- h. **2025-011230-HDRB, 527 Agua Fria Street, Units 1, 2, and 3, Westlake-Guadalupe Historic District, contributing**, Osage Design Studio, agent for Neirika, LLC, owner, proposes to construct a 36 square foot addition, replace windows and doors, raise two sections of roofing, re-roof, stucco, and other repairs. Exceptions are requested to 14-5.2(D)(5)(a)(i)(ii)(iii) for the replacement of windows on primary facades, and to 14-5.2(D)(3)(a) for raising the roof of a contributing structure.

PROJECT 2025-011230-HDRB, 527 Agua Fria St. units 1, 2, & 3, Westside-Guadalupe Historic District,
DESC: Contributing, Osage Design Studio, agent for Neirika, LLC, owner, proposes to construct a 36 sq. ft. addition, replace windows and doors, raise two sections of roofing, re-roof, stucco, and other repairs. Exceptions are requested to 14-5-2(D)(5)(a)(i)(ii)(iii) for the replacement of windows on primary facades.

DATE: January 13, 2026

2025-011230-HDRB, 527 Agua Fria St. units 1, 2, & 3, Westside-Guadalupe Historic District, Contributing, Osage Design Studio, agent for Neirika, LLC, owner, proposes to construct a 36 sq. ft. addition, replace windows and doors, raise two sections of roofing, re

Figure 3: Façade Diagram

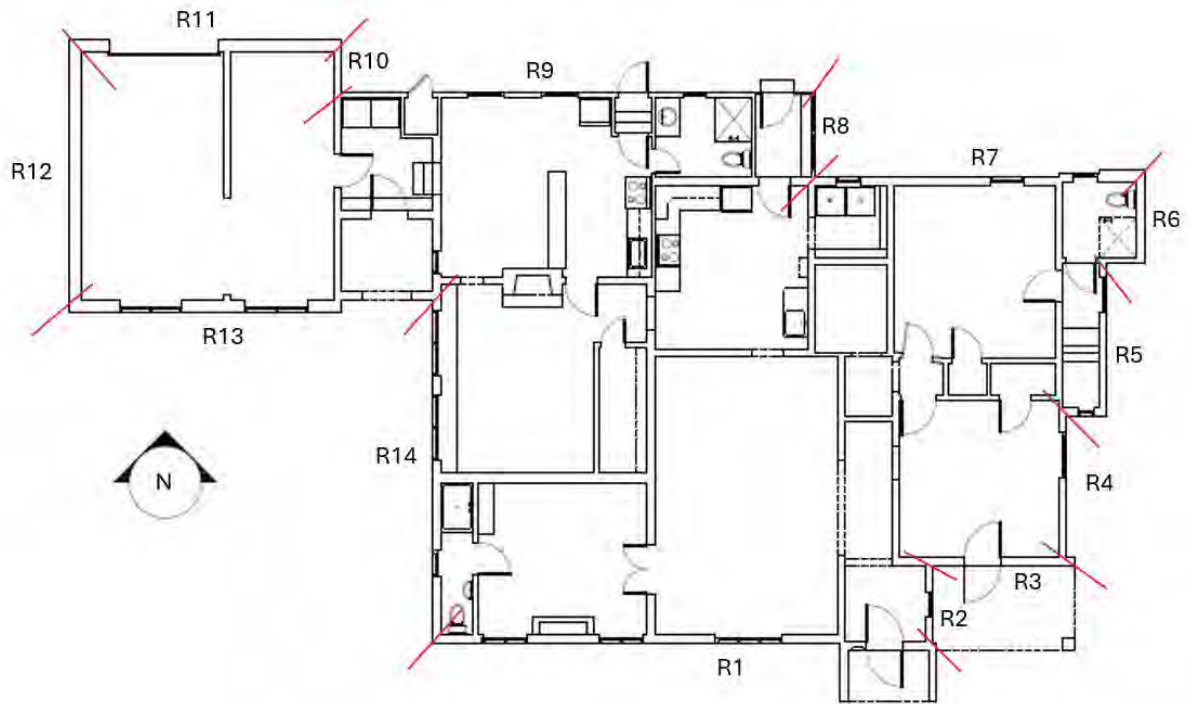
Ms. McCulley responded that they are the south elevation, larger sections and the entire east elevation.

Ms. McCulley clarified that Windows F, G, H, I, J, and L were on the primary façade. Staff recommended replacing Door 2 be in kind to maintain its arch. The applicant wishes to make Door 3, which is wooden, into a window, which would be smaller than the door.

Figure 3: Window Schedule

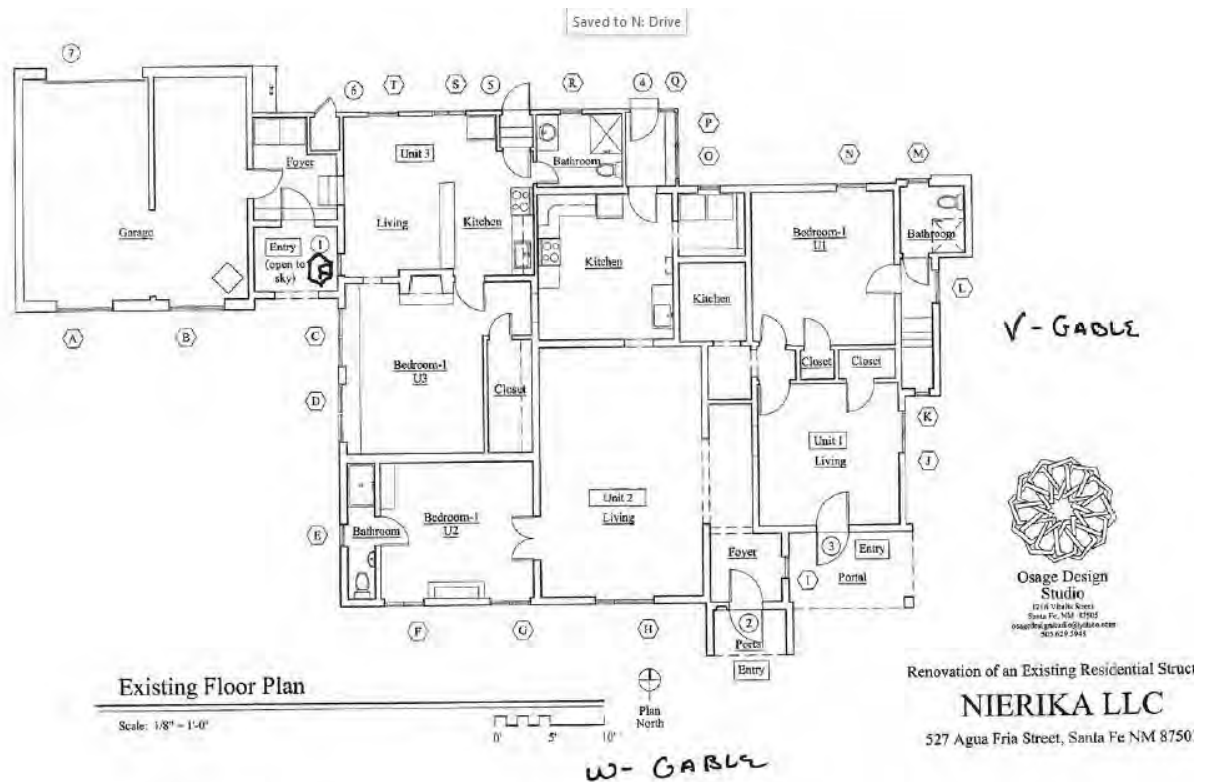
- a. Window replacement in the same size opening at F, G, H, I, J, L, M, O, P, R, S, T, and V. Windows F, G, H, I, and J are historic and restorable. Window O is historic; however, unrestorable. Windows L, M, P, R, S, T, and V are non-historic. Windows F, G, H, I, J, and L are all located on primary facades.

- b. Window replacement with a new size at window E, which is a non-historic window, and not located on a primary facade.
 - c. Window Q will be infilled as part of the structural changes on the north elevation. This window is non-historic, and not located on a primary facade.

- d. Window N will be converted to a door. Window N is historic, however, not part of the original house, and not located on a primary facade.
 - e. Two new windows where there are currently no openings will be in the addition, and on the north elevation wall.

- f. A new door opening at the accessory dwelling unit.
 - g. Doors 1 and 3 (door 3 is on a primary façade) are to be replaced with windows; both are non-historic.

- h. Door 2 (on a primary façade) is to be replaced without a size change, but the shape will be changed to rectangular with no arc, and the swing will be reversed.

- i. Door 4 will be increased in size. According to the window assessment, it is historic, however, not of the original house, and is not located on a primary façade. The current unit has cut stiles and rails. The unit is lacking in structural integrity.

- j. Doors 5 and 6, removed with reconstruction of space and addition, both are non-historic and are not located on a primary façade.
- k. Door 7 will be decreased in size to convert from a vehicle door to a pedestrian door. This door is currently missing and is not located on a primary façade.

- l. The east and south gable diamond vents are to be replaced with metal louvered vents for attic exhaust, painted white to match the fascia. The east and south gable vents should open for venting; however, they have glass on the inside and do not vent to facilitate attic airflow.

Staff Response: Staff finds that this criterion is not met for items 1a, 1g, 1h, and 1l. The windows are deemed as repairable per the window assessment. Replacing historic windows when unnecessary does damage the character of the historic district.

Staff Response: Staff finds that this criterion is not met. Window replacement for the non-historic window L, can be considered because this window is non-historic, irreparable, and will be replaced in the same size openings. However, window replacement for the historic windows F, G, H, I, J, which can be repaired; repair is not under consideration in this application. According to the window assessment rating, these historic windows are in satisfactory condition and, therefore, are repairable. There is no hardship in retaining these windows.

Replacement of the non-historic doors can be considered. However, the front door that arcs at the top to match the portal is unique and a part of the character of the building. The door shape should be retained.

1. h) Replacement of Door 2 (on a primary façade) at the main entrance. The door may be replaced and the swing reversed on the condition that the arc of the door is not altered.

1. a) The replacement of windows F, G, H, I, and J finding the exception criteria are not met, and
1. l) The replacement of the gable diamond vents with metal louvered vents.

Figure 5: Area of Addition on North Elevation

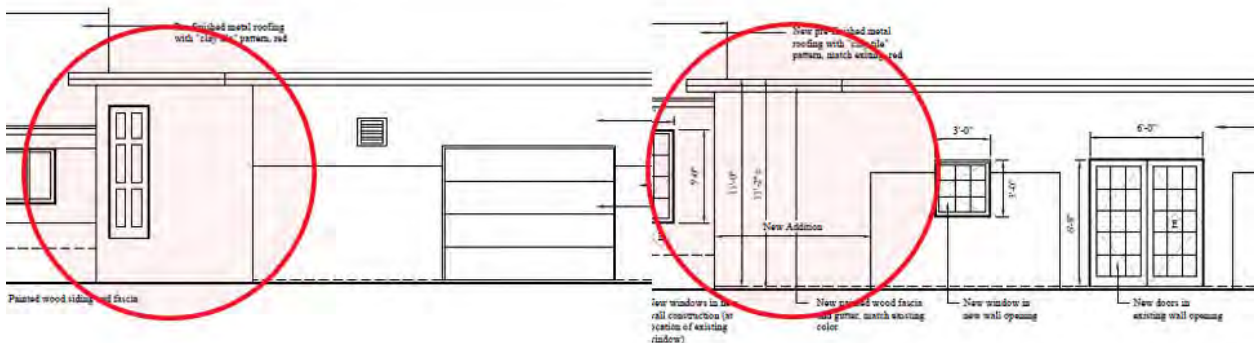
- 3) Construct a 36. sq. ft. addition to a height of 11'-2", where the maximum allowable height is 17'-8" on the north elevation. The addition will have a pre-finished metal gutter, downspout, and rain barrel. The addition is not on a primary façade nor is it within 10' of a primary façade.

- 3) Construct a 36. sq. ft. addition to a height of 11'-2", where the maximum allowable height is 17'-8" on the north elevation. The addition will have a pre-finished metal gutter, downspout, and rain barrel.

Figure 6: Area of Chimney on North Elevation

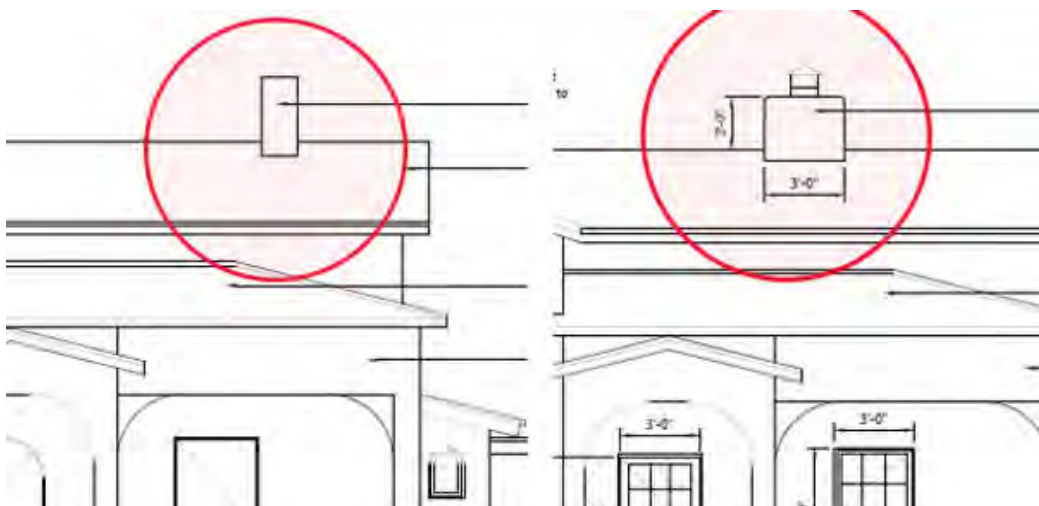
- 4) Replace a chimney to meet current fire code and remove the metal flue for the wood stove that is currently on the northwest roof area. The chimney and flue are not located on primary facades.

- 4) Replace a chimney to meet current fire code and remove the metal flue for the wood stove that is currently on the northwest roof area.
- 5) Construct a 6'-0" high coyote fence with 6'-0" pedestrian gates on the north of the residence to replace the existing 6'-0" high wood plank fence.

Existing Front (South) Elevation

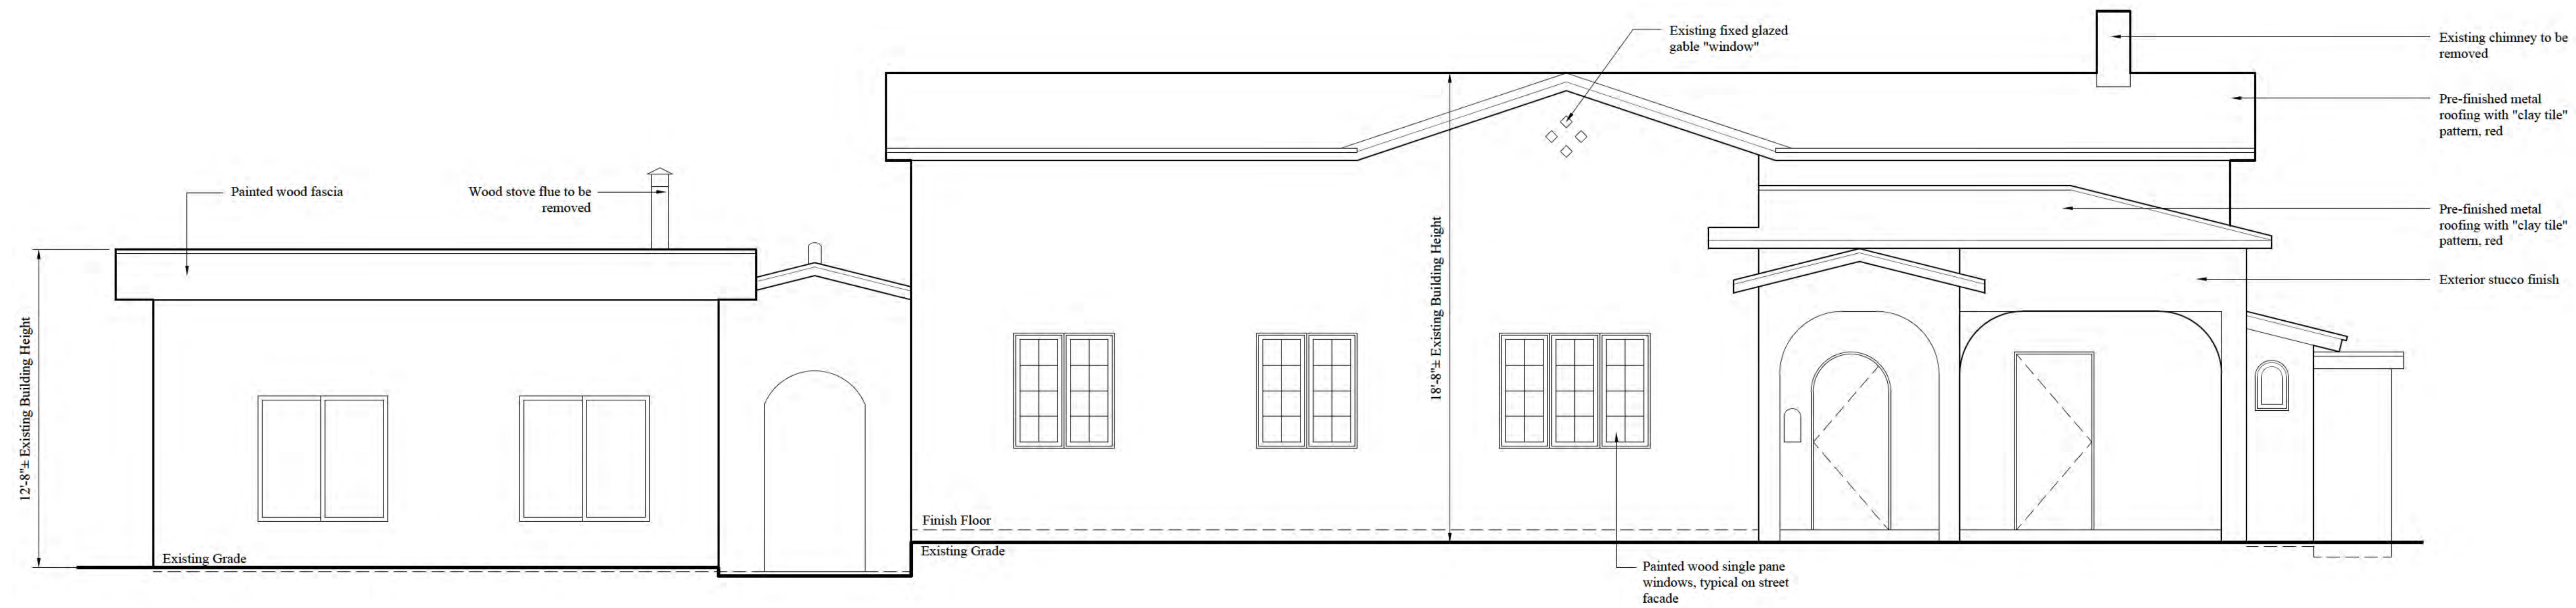
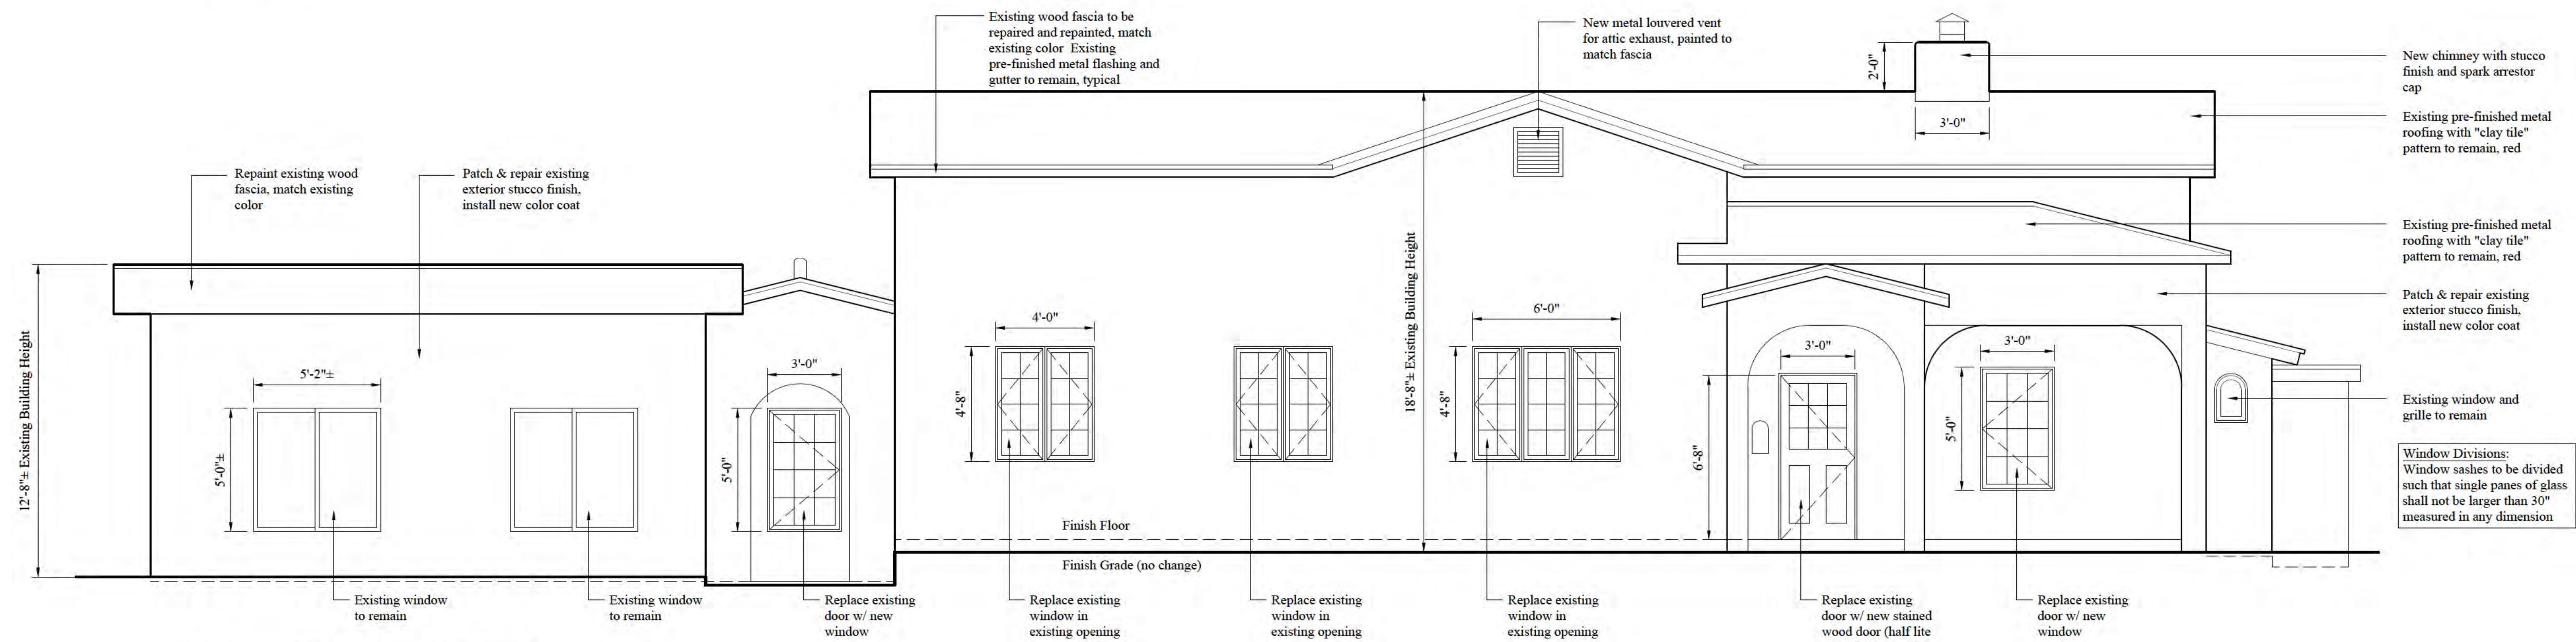
Mr. Woodbury noted that the diamond gable vents could be repaired, but that there are currently two front doors. He wishes to change Door 3 to a window and replace Door 2 with a wood-panel door with lights.
